DEPARTMENT OF TRANSPORTATION

National Highway Traffic Safety Administration

Federal Motor Vehicle Safety Standards; Designated Seating Positions

ACTION: Final rule; response to petitions for reconsideration.

Figure 1: Global Automakers Seat Surface Width Measurement Example

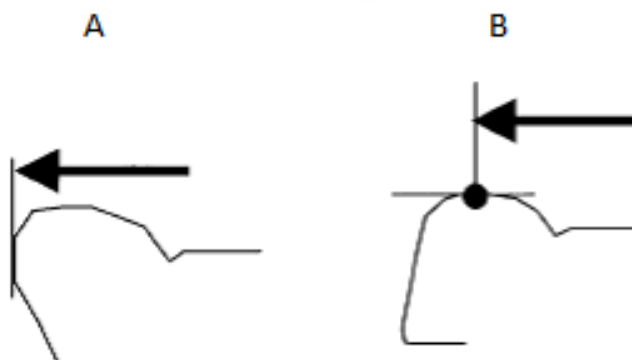
Global Automakers and Toyota requested that the agency clarify its position on how the seating surface width is measured. Global Automakers raised two specific scenarios. The first scenario involves seat cushions whose outer edge slopes downward. Global Automakers was not certain whether the measurement will be made from the outer edge of the seat cushion (identified in A in Figure 1) or the point where the top surface of the cushion begins sloping downward toward the side of the seat (identified as B in Figure 1). Toyota interprets the language as contemplating the seating surface width measurement to take place between the vertical planes tangent to the outboard edges of the seat, as indicated in Figure 2. Toyota stated that if its interpretation is not correct, it was petitioning the agency to adopt its position.

NHTSA agrees with Toyota's interpretation that the seating surface width will be determined from the maximum width between the vertical planes tangent to the outboard edges of the seat. We note that in the context of seat width measurement, the determination of what is outboard is made with respect to the seat orientation and may not align with what is outboard with respect to the vehicle. This measurement procedure is more objective than the other measurement procedure suggested by Global Automakers. It is not always clear at what point the top surface of the seat cushions begin to slope downward to the side because such surfaces may be rounded or uneven and seat cushions can be pliable.

NHTSA would measure the seating surface width from the plane indicated in drawing A on Figures 1 and 3 above. NHTSA would only consider a trim component in the determination of the seating surface width if the trim makes contact with the top of the seat within the measurement zone. To make this clearer, we are adding specificity to the determination of the “seating surface width.”

Figure 3: Global Automakers Seat Surface Width Measurement with Armrest

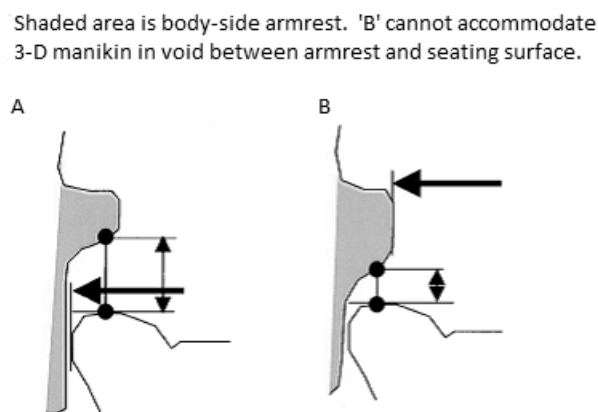
Global Automakers also requested that the agency clarify its interpretation on how the measurement will be taken for seat cushions whose outer edge extends underneath interior trim. Global Automakers noted that, in some cases (one of which is illustrated in Figure 3 below), the interior trim interrupts the “nominal hip room” using the SAE H-point machine and that an occupant could not use the seating surface under the trim.

Although the agency agrees that, in Global Automakers’ example, some portion of the “seating surface” may not be a location where an occupant could actually sit, the amendment to the DSP definition was designed to make the definition more objective. The new definition is not based upon non-objective concepts such as the usability of the seating surface by the occupant or “nominal hip room.” Manufacturers will have to consider the usability of the space in designing the vehicle; however, the DSP definition and measuring procedure make no allowance for seating space that is made unusable by the positioning of trim components such as body-side armrests.

Figure 4: SAE Examples of Seat Measurement with Trim
(Seats in both examples are viewed from above)

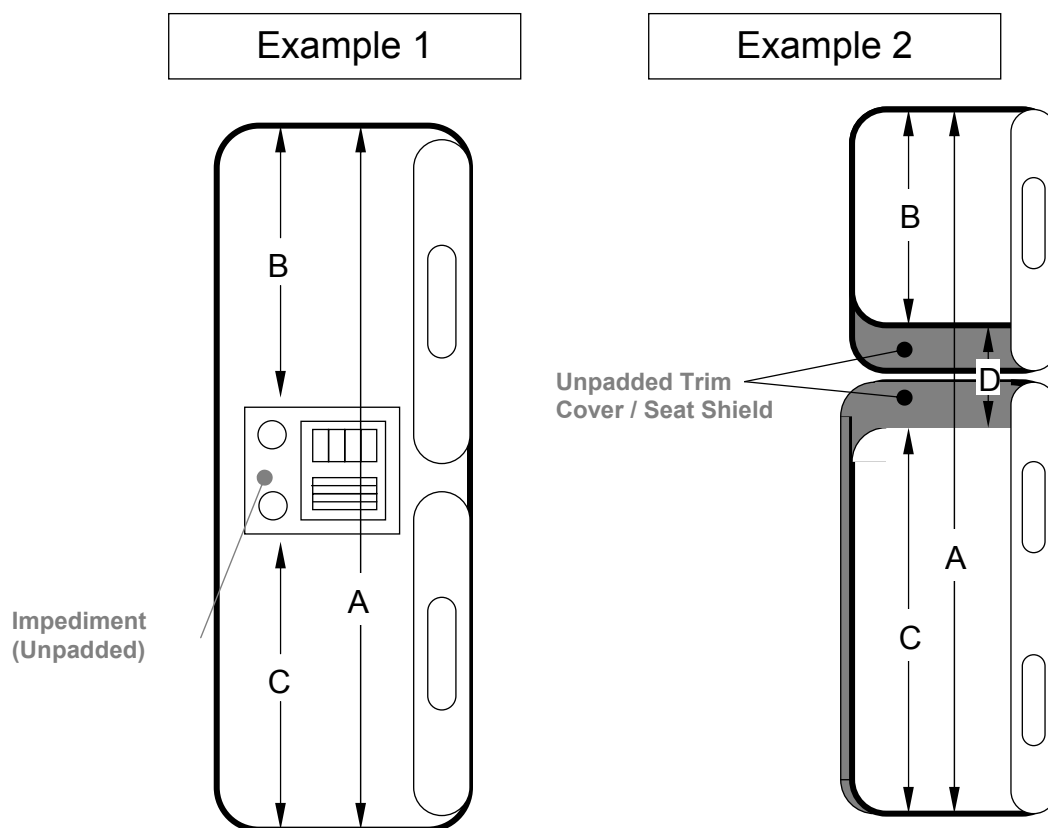
SAE requested clarification on how the agency would consider trim when measuring the seating surface. SAE provided two illustrated examples, shown below, and asked for NHTSA's clarification on how "trim" would be defined.

In Example 1, SAE described an impediment in the middle of the seat as an “embedded convenience system.” During the seating surface measurement, the agency would first determine if the impediment meets the requirements of sections 571.10(c)(2)(i)(A) or 571.10(c)(2)(ii). SAE stated in its request that it was assumed that the conditions of section 571.10(c)(2)(ii) were not met by the impediment.⁷ Therefore, a determination would need to be made as to whether the impediment was “a fixed trimmed surface whose top surface is unpadded and that has a width not less than 140 mm (5.5 inches), as measured in each transverse vertical plane within that measurement zone.” Such a determination is impossible to make from the schematic provided and may only be possible from a physical examination of the impediment. If the

impediment satisfied the criteria, the seating width would end at the impediment's edge, as shown by dimension "B" and "C." However, if the impediment did not satisfy the criteria, the agency would define the maximum seating surface width as shown by distance "A" in Example 1. We think this is clear from a reading of section 571.10(c)(2).

SAE asked about the measurement procedure with respect to Example 2. We believe this has been made clear both in the regulation and the agency's test procedure. Assuming the shaded area is fixed, unpadded trim surface, the determination of seat surface width depends on whether the length of "D" is less than 140 mm. If "D" is less than 140 mm, then seating surfaces "B" and "C" form a continuous seating surface and the number of DSPs would be calculated using measurement "A." If "D" is at least 140 mm, seating surfaces "B" and "C" would have sufficient separation such that the number of DSPs for seating surfaces "B" and "C" would be calculated separately based on the length of "B" and "C."

Plan view of a seat showing several example measurement locations for the determination of seating surface width. Measurement 1 is the seat surface width for this illustration.

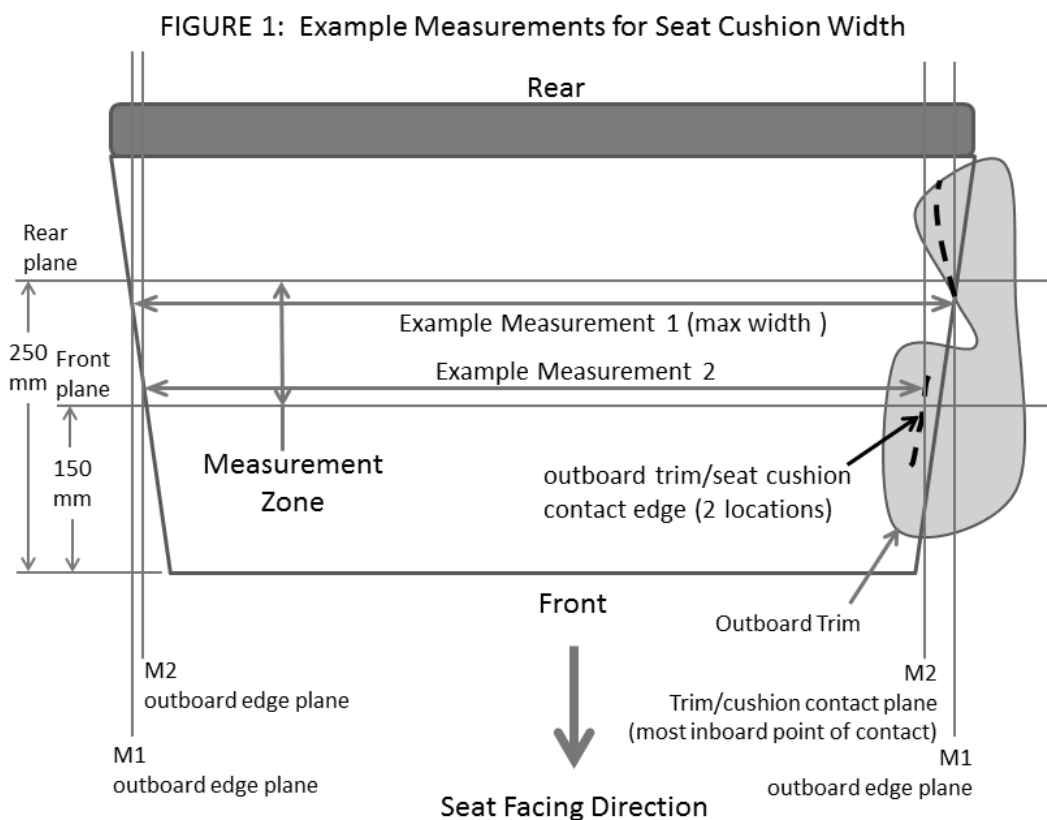
2. In § 571.10, revise paragraphs (b)(1), (b)(2), (c)(1), and (c)(2)(ii) and add paragraphs (c)(1)(i) through (iii) and Figure 1 to read as follows:

(i) Establish a measurement zone bounded by two vertical planes oriented perpendicular to the direction the seat is facing. One is located 150 mm (5.9 inches) behind the front leading surface of the seat and the other is located 250 mm (9.8 inches) behind the front leading surface of the seat. A measurement location within this zone is any vertical plane parallel to the planes establishing the boundary of the zone.

(ii) For each measurement location within the zone, establish vertical reference planes parallel to the direction the seat faces that intersect the most outboard point on each side of the seating surface at that measurement location. If outboard interior trim contacts the top surface of the seat cushion, establish another vertical plane parallel to the direction the seat faces that intersects the most inboard point of contact between outboard interior trim and the top surface of the seat cushion.

(iii) For measurement within the zone, measure horizontally between and perpendicular to the most inboard vertical reference planes established in (ii), as shown in Figure 1 (provided for illustration purposes).
